HISTORIC PRESERVATION BOARD  
CITY OF PORTLAND, MAINE

PUBLIC HEARING  
84 COMMERCIAL STREET

**TO:** Chair Sheridan and Members of the Historic Preservation Board  
**FROM:** Deb Andrews, Historic Preservation Program Manager  
**DATE:** September 27, 2018  
**RE:** October 3, 2018 PUBLIC HEARING

**Application for:** Certificate of Appropriateness for Proposed Exterior Alterations,  
Building Additions and Site Alterations  
**Address:** 84 Commercial Street  
**Applicants:** Dry Dock, 84 Commercial Street LLC  
**Property Owner:** 84 Commercial Street LLC  
**Project Architect:** Bill Hopkins, Archetype

7 | UPPER DECK ELEVATION  
1/8" = 1'-0"

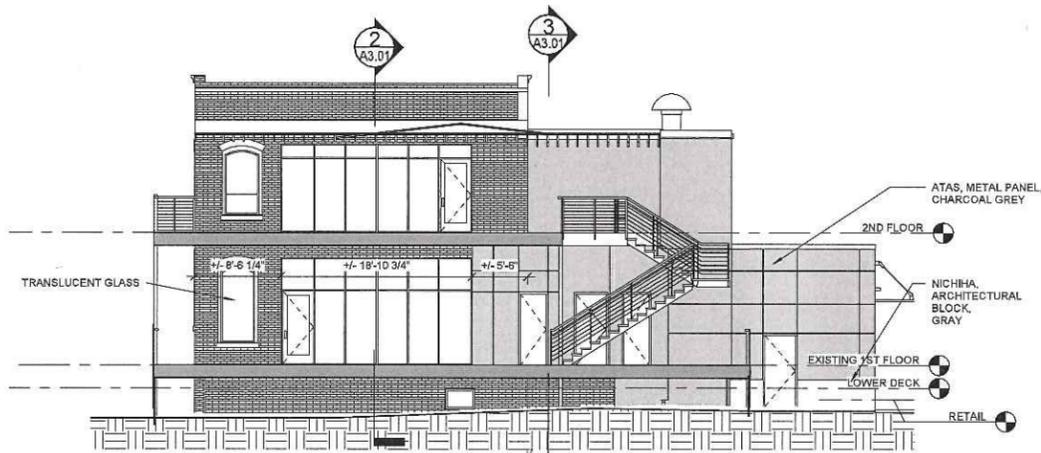
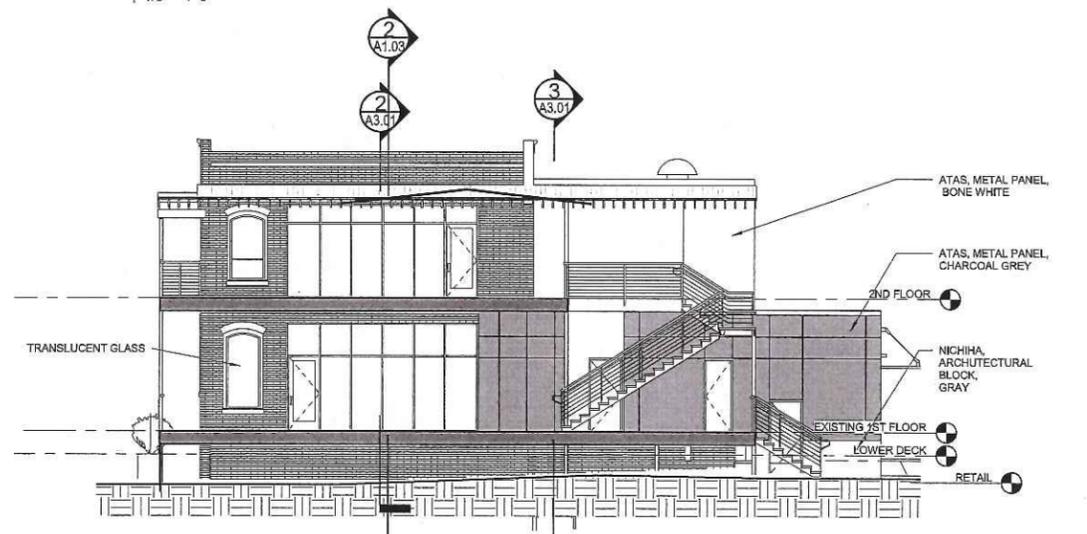
- Second Floor Deck: Concerns were raised about the proposed width of the second-floor rear deck and the fact that it extended beyond the outside edges of the existing structure. Although Board members acknowledged that the decks currently exceed the width of the building, they found the addition of a second-floor roof canopy over the deck to be visually distracting. Board members noted that these projections contributed to a general concern about the cumulative effect of the proposed alterations and additions and the potential for undermining the architectural integrity of the existing building. Board members recommended that, at a minimum, the outside edge of the roof/canopy be pulled back and confine it to the area width of the existing building.

- Rear decks. One Board member noted that the rendering of the rear decks and canopies was likely misleading, as it depicted the decks and canopies as having a very light visual appearance. In reality, the decks and canopy will likely need to be heavier to provide the necessary structural support, etc. The project architects were encouraged to provide more accurate renderings with the second submission. The consultants were also asked to consider what exterior lighting would be proposed for the rear decks.

- Deck Railing Types. Some Board members questioned the proposal to introduce different railing types for the first and second floor decks and recommended that a cable railing be used throughout.

1. Front door is shown as is
2. Gate removed on commercial street
3. Exit door at ATM location shown at grade
4. Kitchen door noted as hollow metal
5. Kitchen and retail additions shown with same color
6. Mullions eliminated on retail windows
7. Bump out at southeast corner of kitchen addition removed. East wall shown as flush.
8. Roof at southwest corner of exterior roof removed
9. Roof modified for items 6 and 7' Cable rail noted on all guard and hand rails
10. West elevation shown as is

5 | EAST ELEVATION  
1/8" = 1'-0"

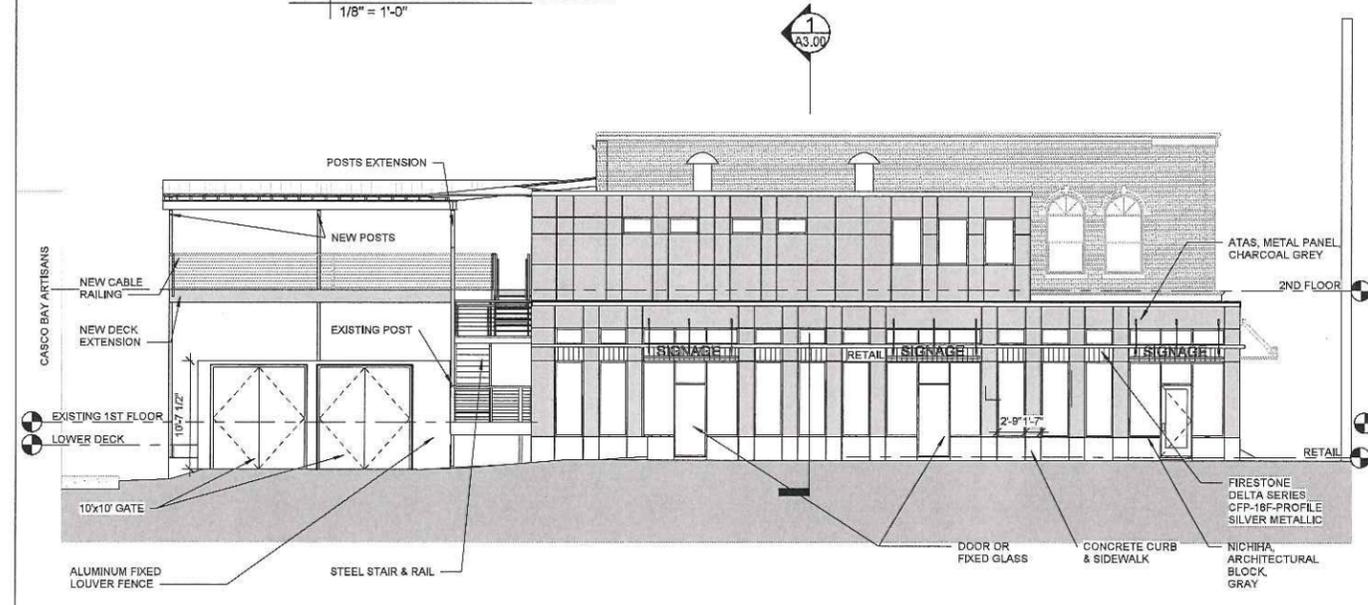
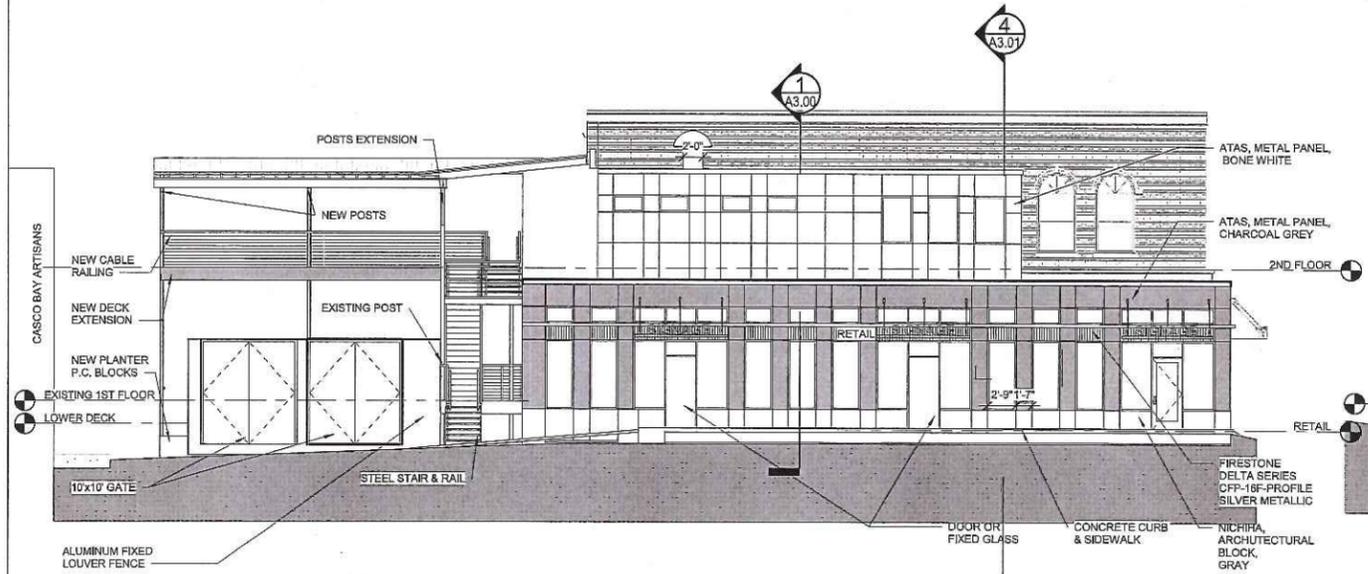
- Position of Elevator Enclosure on East Side: Board members requested that the elevator enclosure be pulled back from the southeast corner of the building to simplify the massing of the addition.

- Alignment of Kitchen Addition Windows: It was noted that the second-floor windows on the kitchen addition did not appear to align exactly with the tops (or bottoms) of the existing building's second floor windows. The architect was asked to adjust the alignment.

Staff notes one additional design change not included on Mr. Hopkins' list. A number of the large storefront windows on the east elevation of the retail addition have been replaced with narrower windows.

6 | WEST ELEVATION  
1/8" = 1'-0"

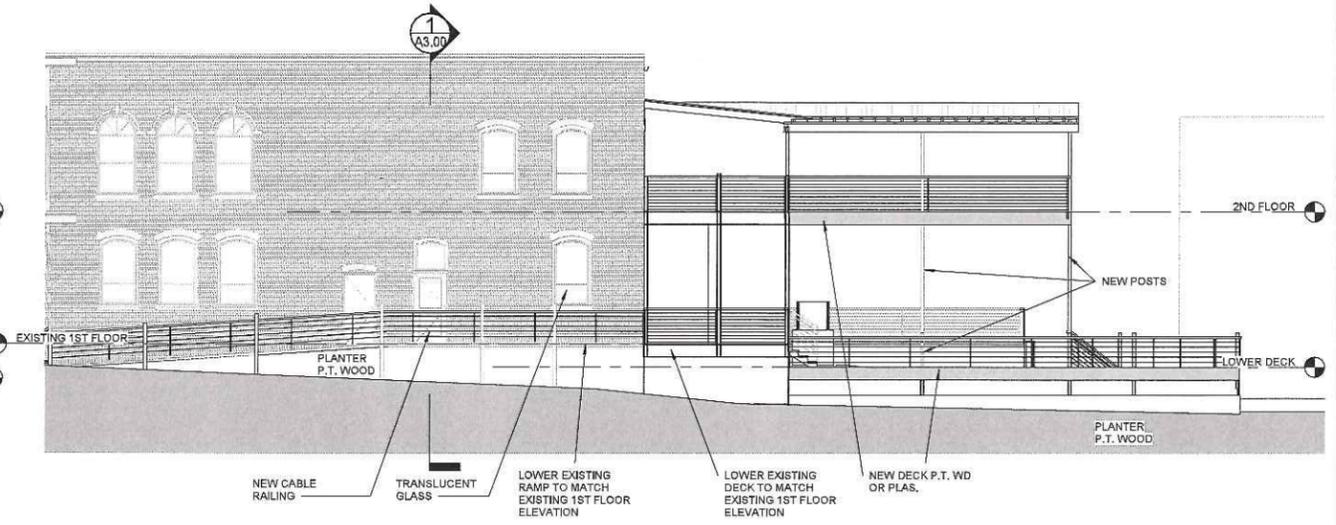
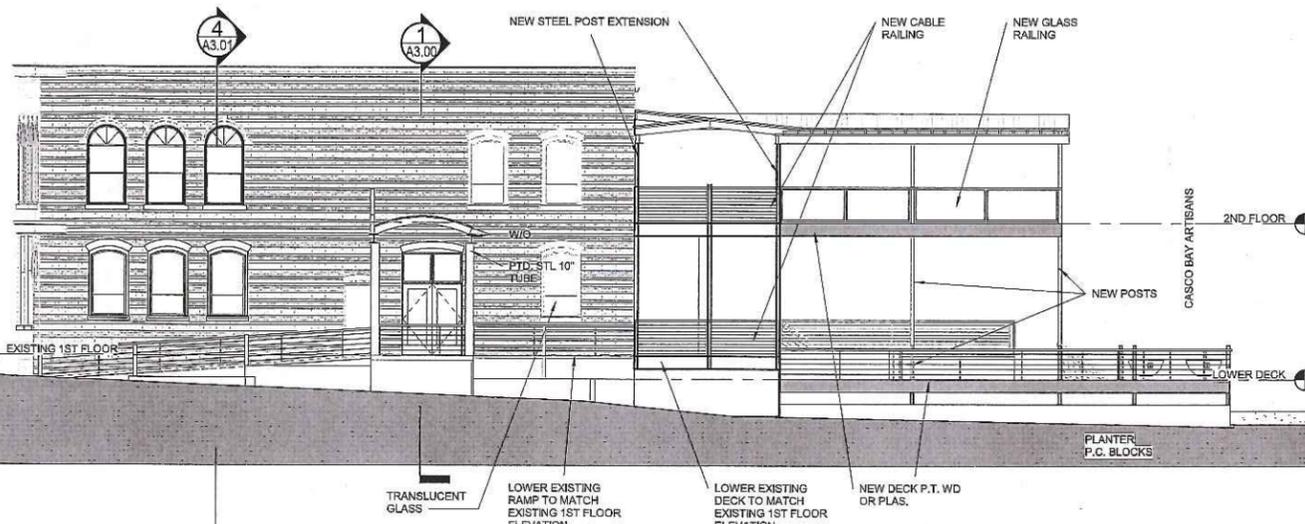
- Proposed Entrance Treatment, West Elevation: Board members expressed concern about the pergola-like structure proposed to highlight the entrance on the west elevation. Board members found the proposed treatment architecturally heavy and exaggerated. They also noted that it diminishes the prominence of the historic main entrance and shifts the directional expression of the existing building. They suggested that lighter support posts be used and the overall treatment toned down. Members also suggested that the same architectural vocabulary be used for the entrance surround as is used for the deck railings.
